**NEBRASKA ARMY NATIONAL GUARD**  
**CATS NE Ave – Boulevard Construction**

**PROJECT NO. 31090433**

**ADDENDUM NO. 1**

### WASH SLAB DETAILS

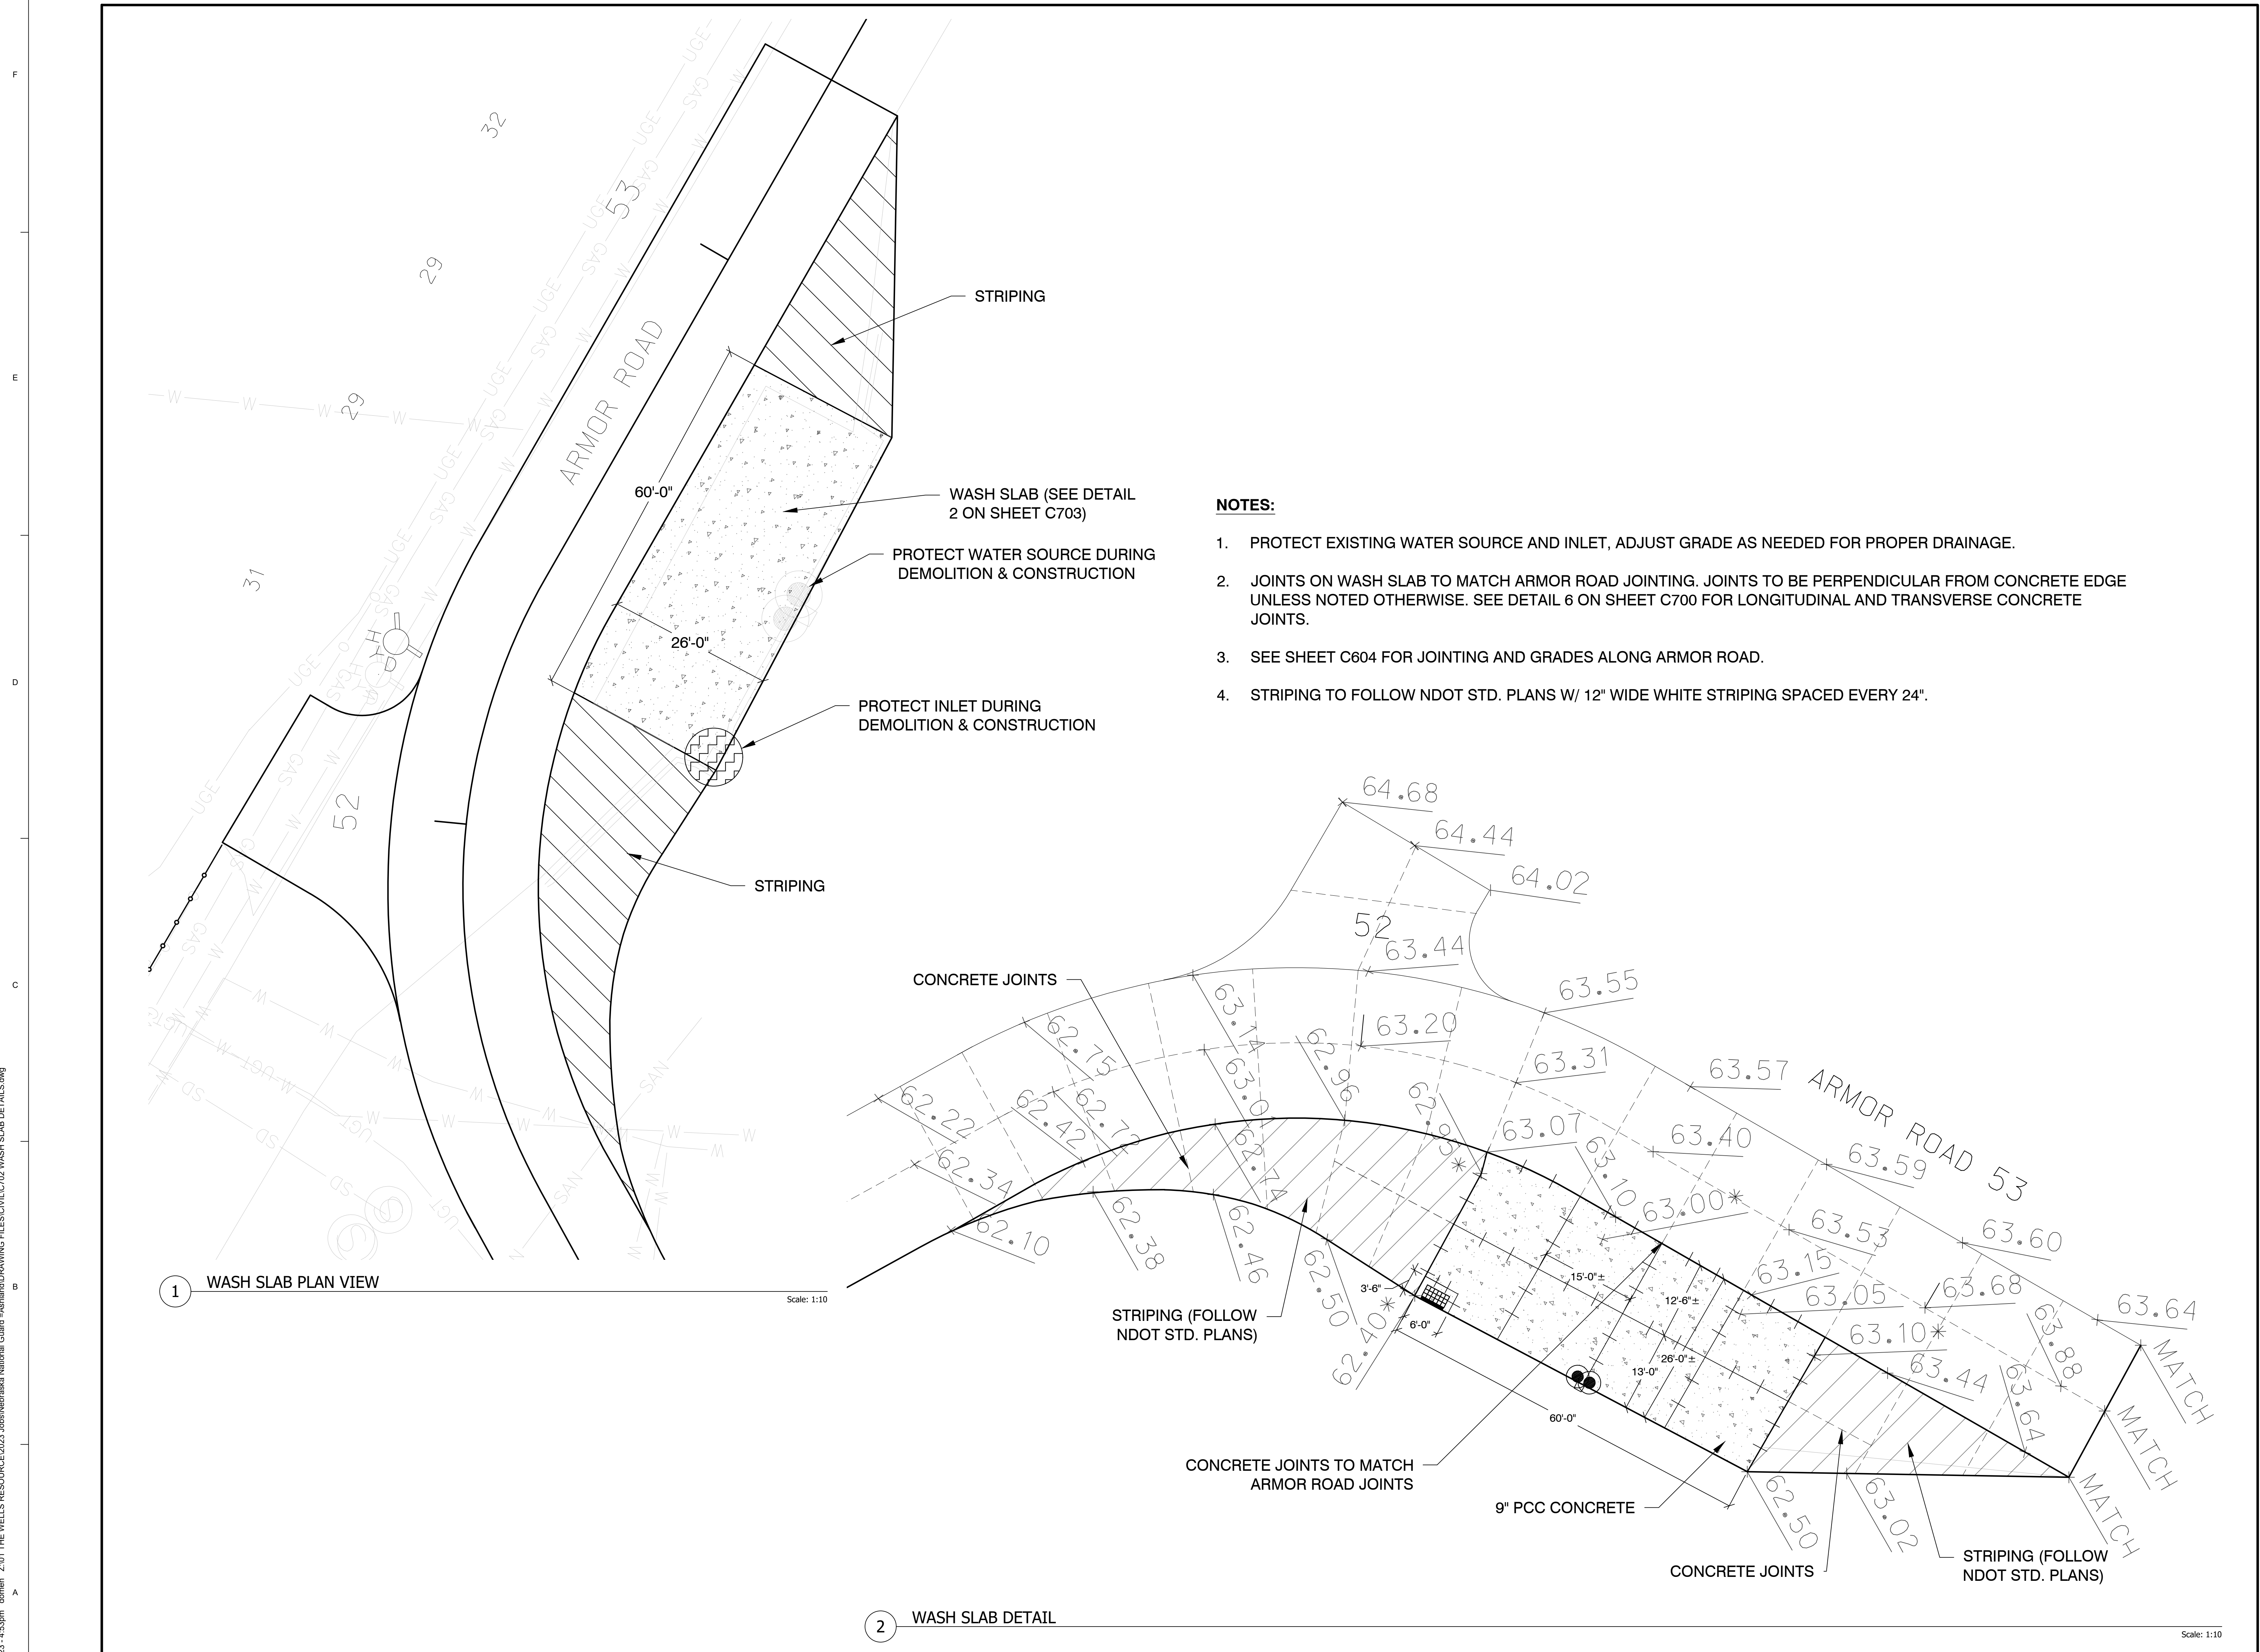
- ADD 1-1: Add Paragraph 23, to IB-6: 22. WARRANTY PERIOD "Warranty Period is standard one-year from project completion including an 11-month walk through.
- ADD 1-2: Add Paragraph 24, to IB-6 : 23. LABOR AND MATERIAL BOND "The Labor and Material Bond are required to be in effect for the duration of the construction contract period.
- ADD 1-3: Add Sheet C-703 WASH SLAB DETAILS to Contract Drawings.

- d) Will a detail of the wash slab be provided? **Yes. See Addendum 1-1.**
  - e) Confirm that a unit price will be added to the addendum? **This will not be added as a unit price bid item. The contractors will include any costs associated with additional fill to complete the project in the base bid.**
